City of Hutto

Planning and Zoning Commission

Tuesday, June 6, 2023 at 7:00 PM

RE: Lidell Walker Phase 1 Final Plat, Hutto, TX 78634
Final Plat Review – Lidell Walker Phase 1 Final Plat - Comment Report to Update #1 Submittal (received 5-8-23)
Project No.: 2057-PLAT

HEC-RAS Plan: Ult_v1 River: Mustang Creek Tr Reach: FLOWLINE Profile: PF 1

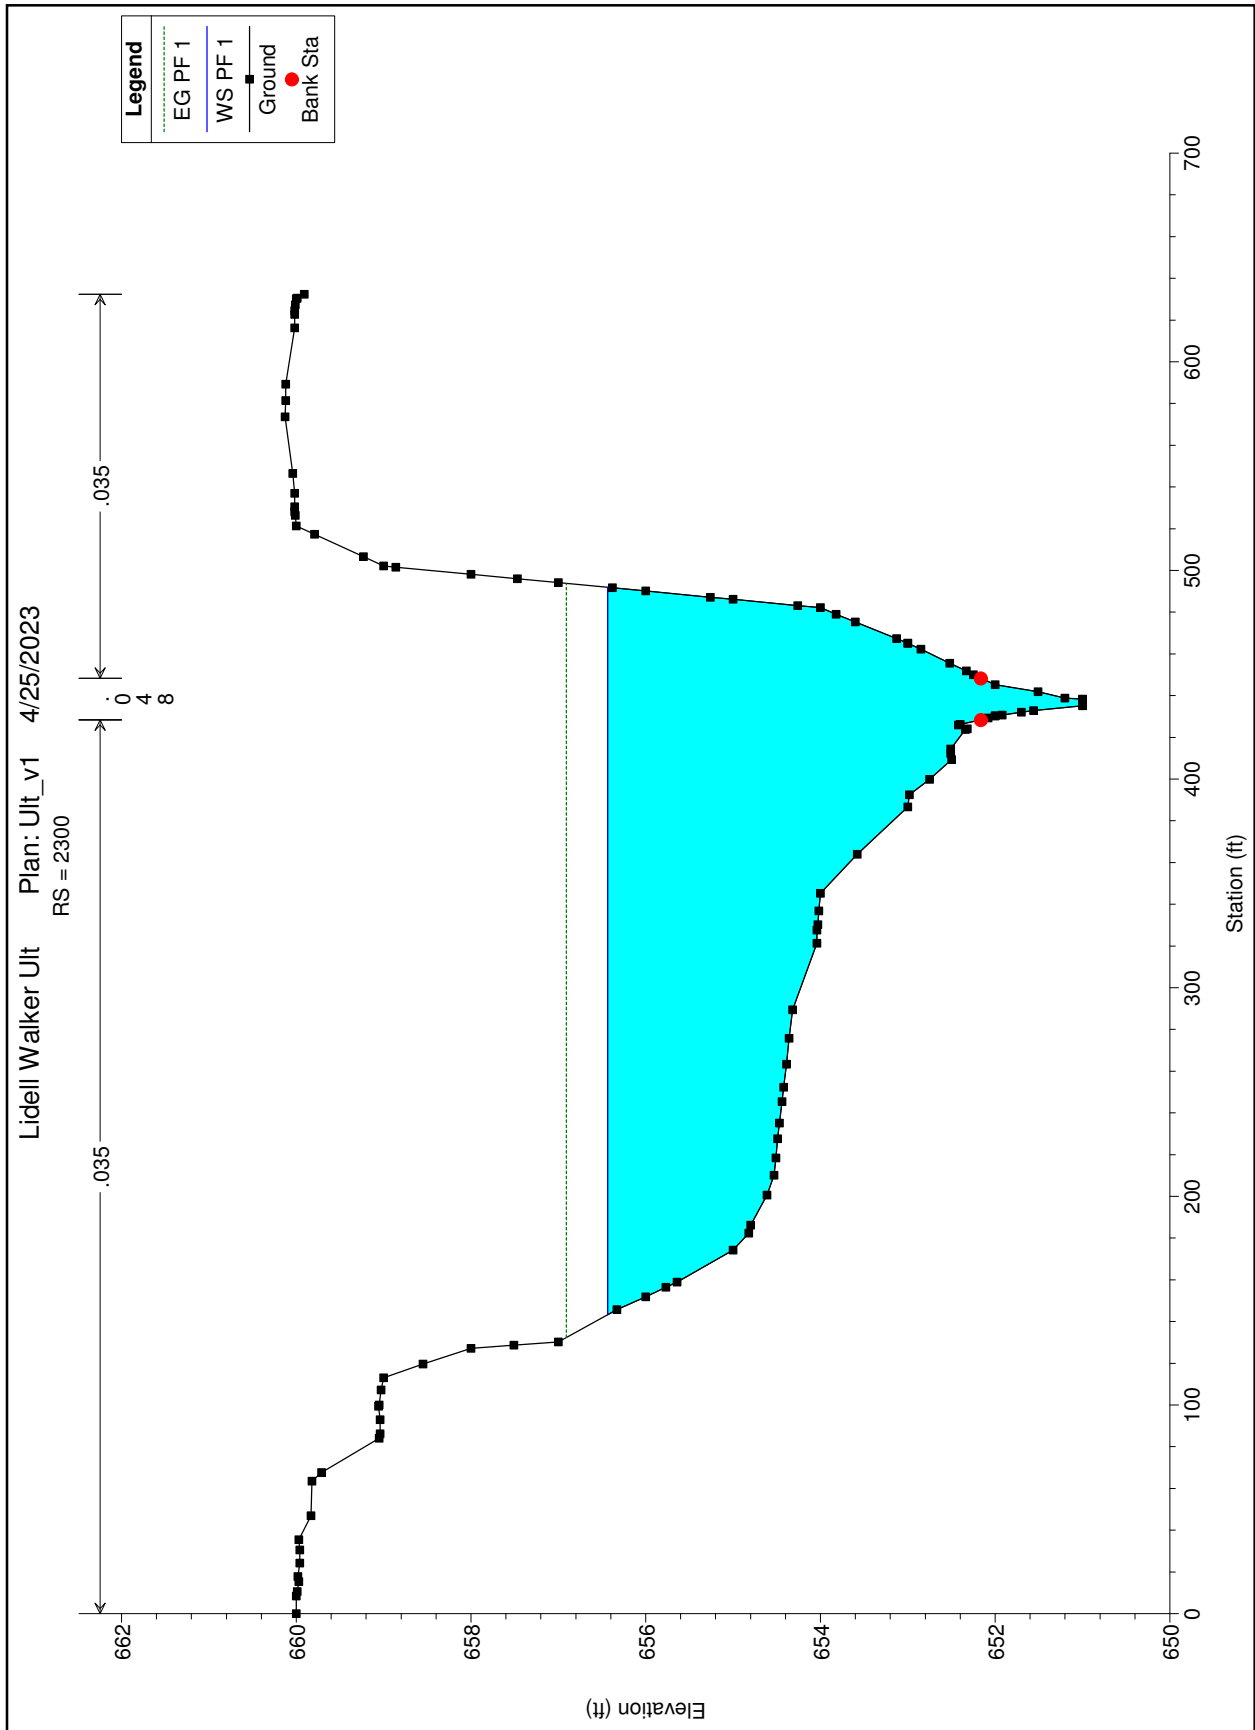
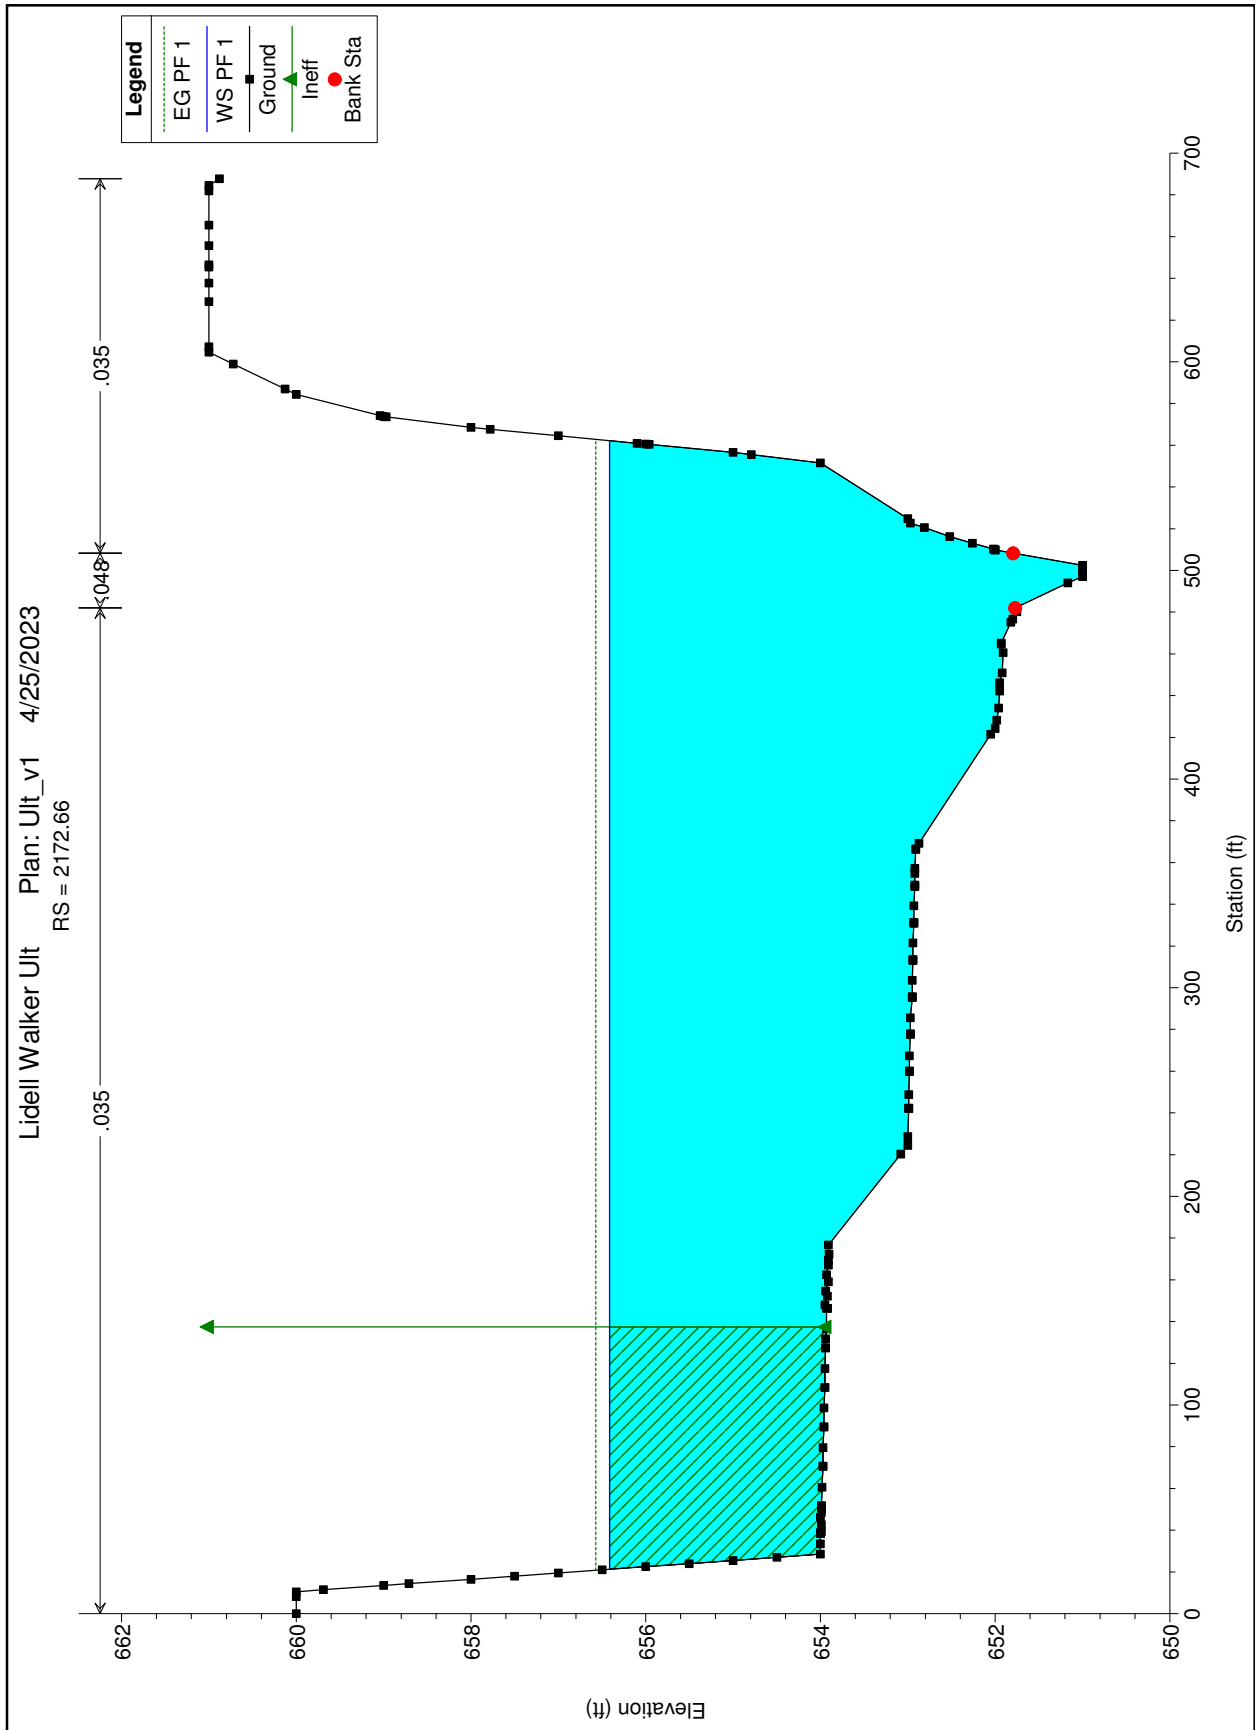
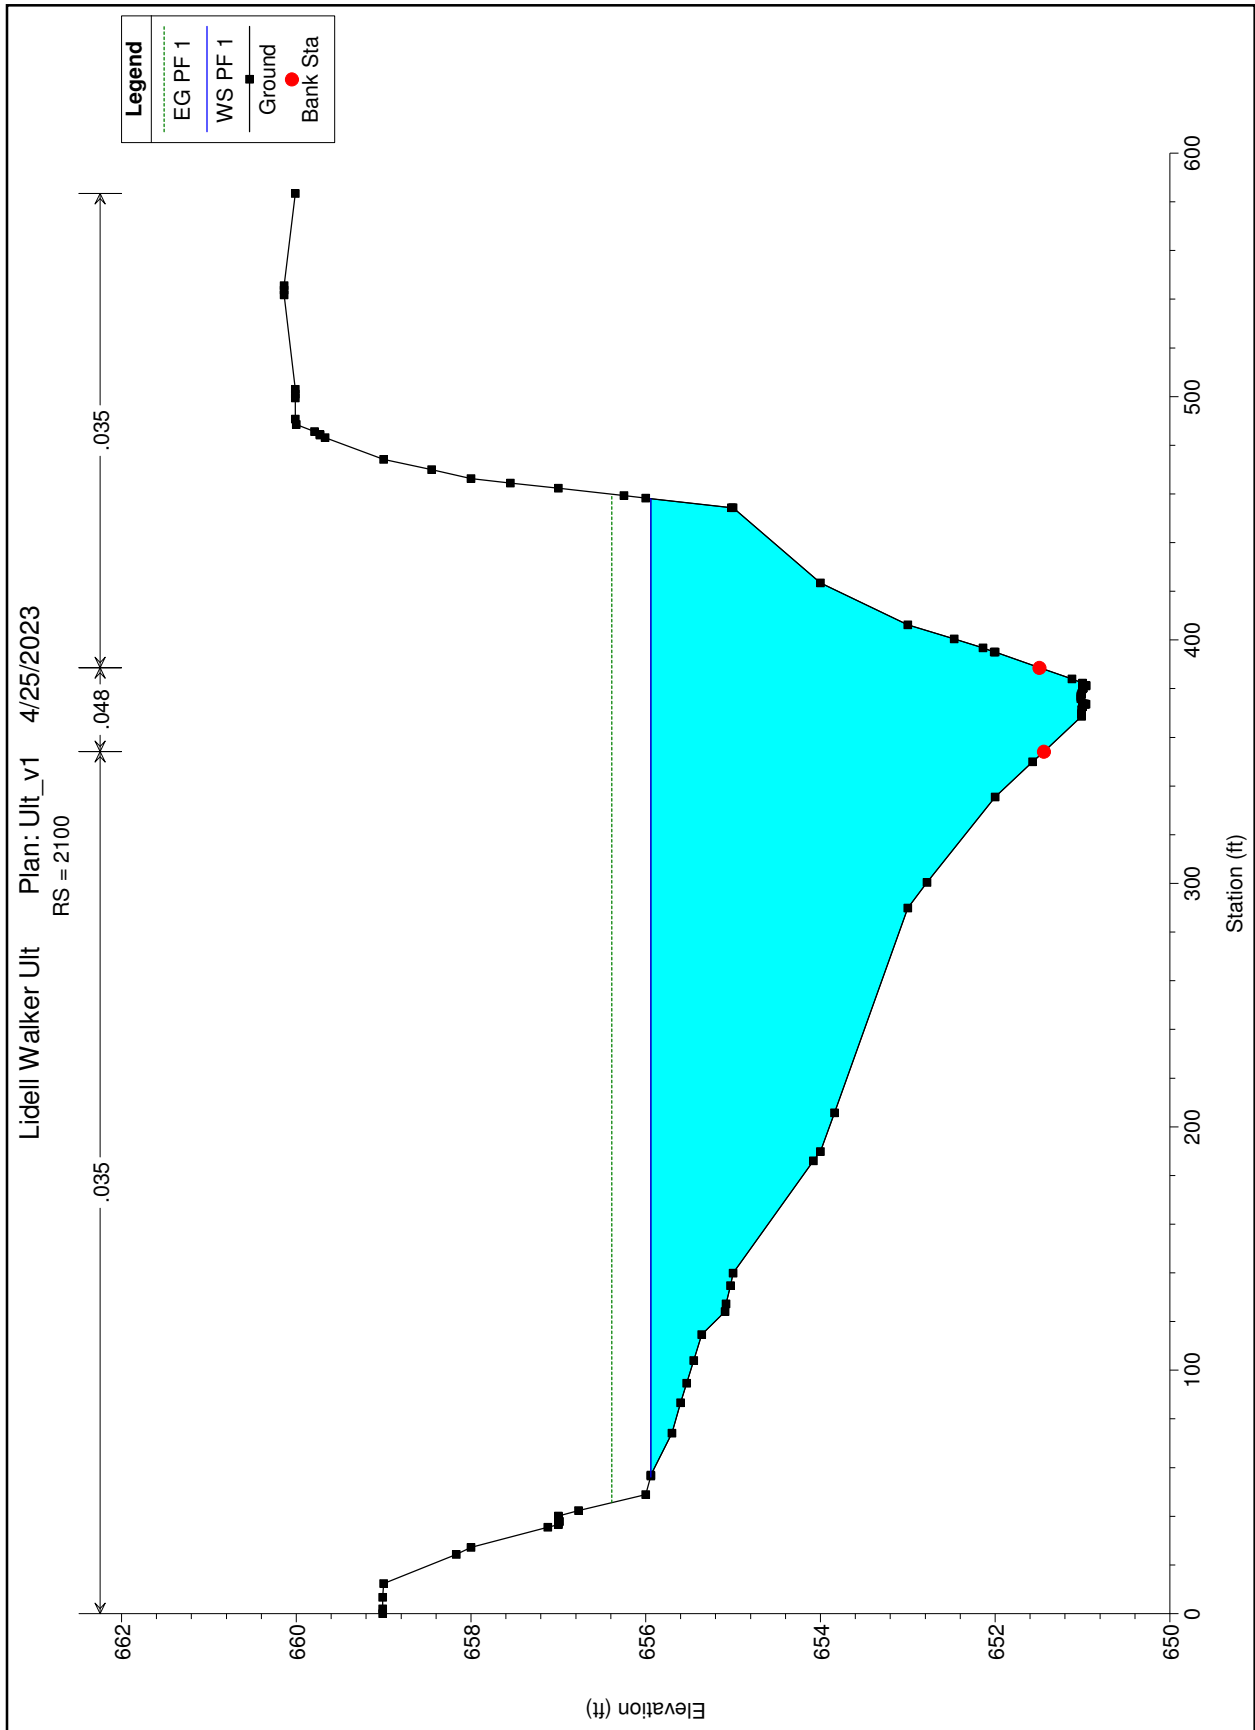
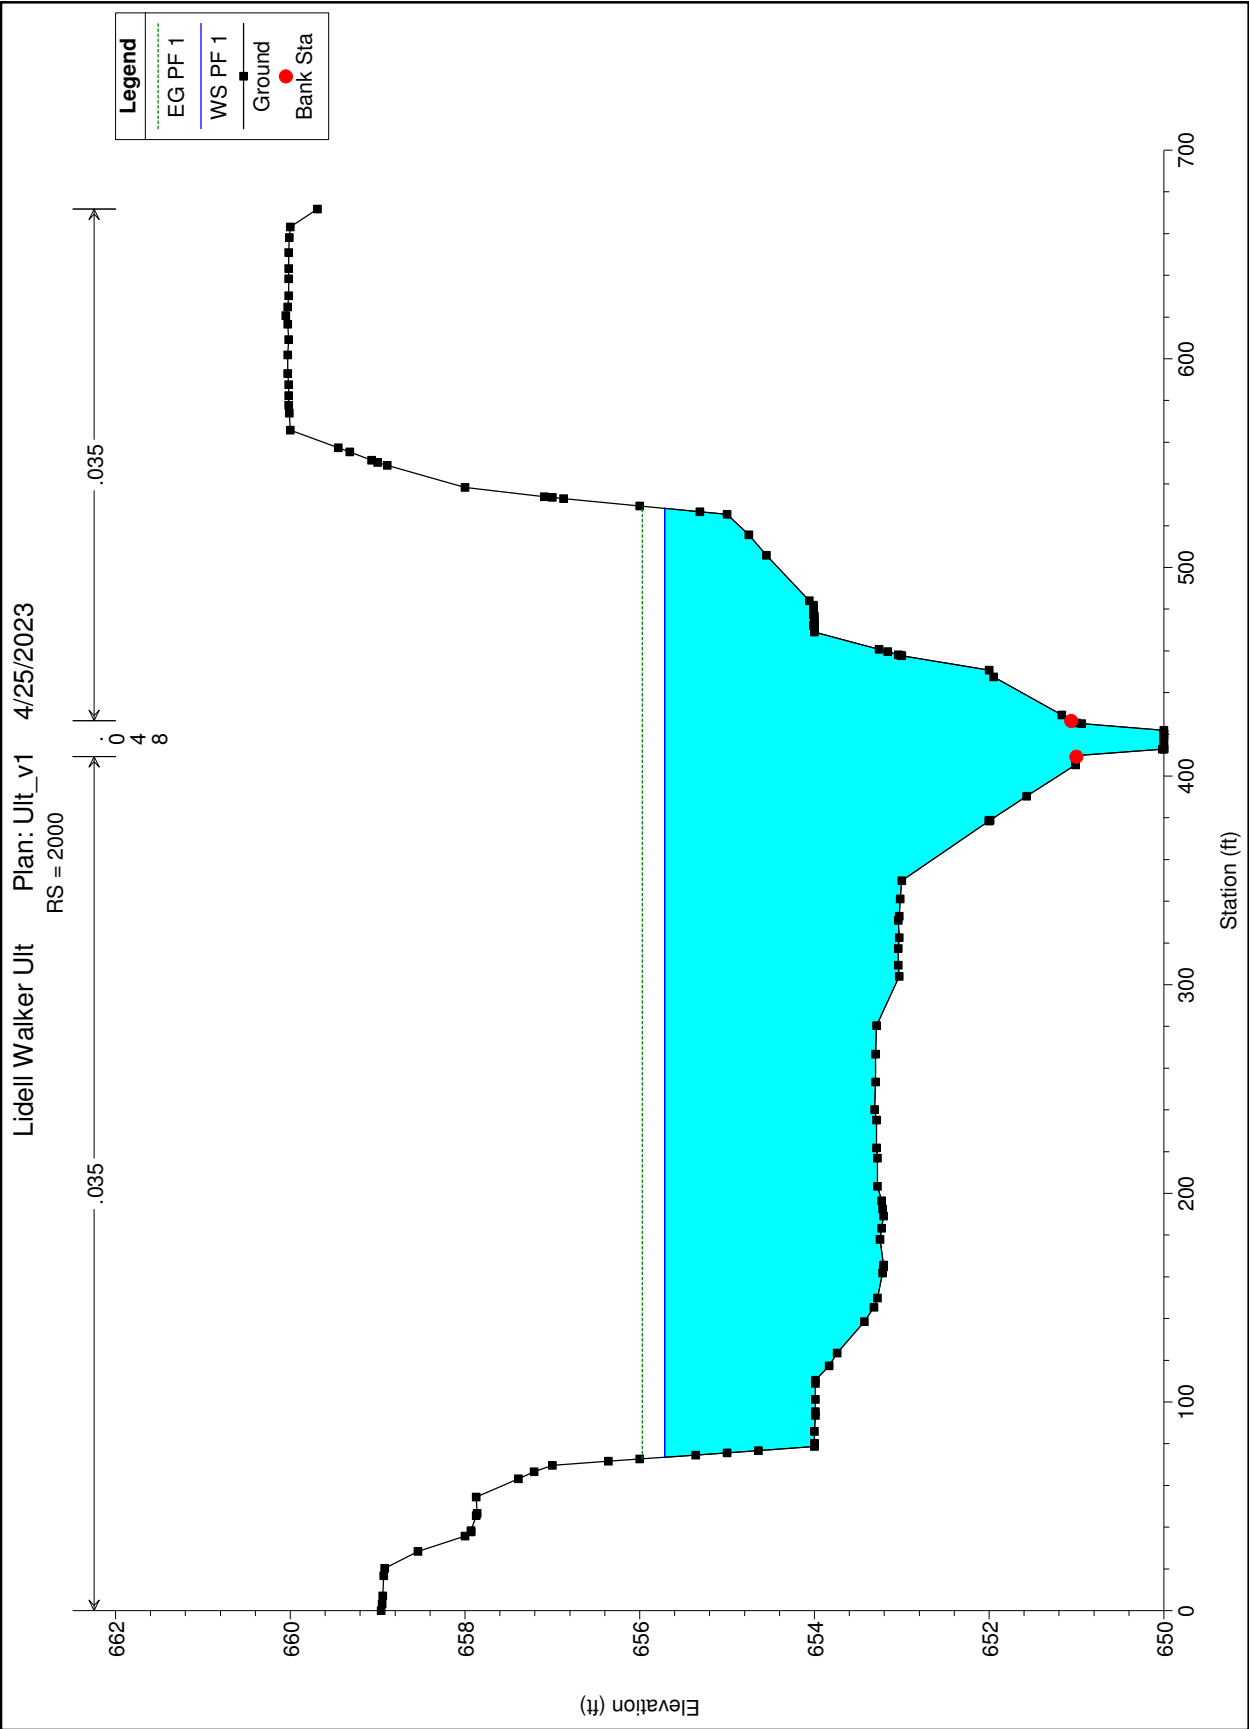
per the DA maps
there should be flow
changes at stations
200, 800, 1300, and
1800.
Per the HMS analysis
the final flow should
be 4827.60.
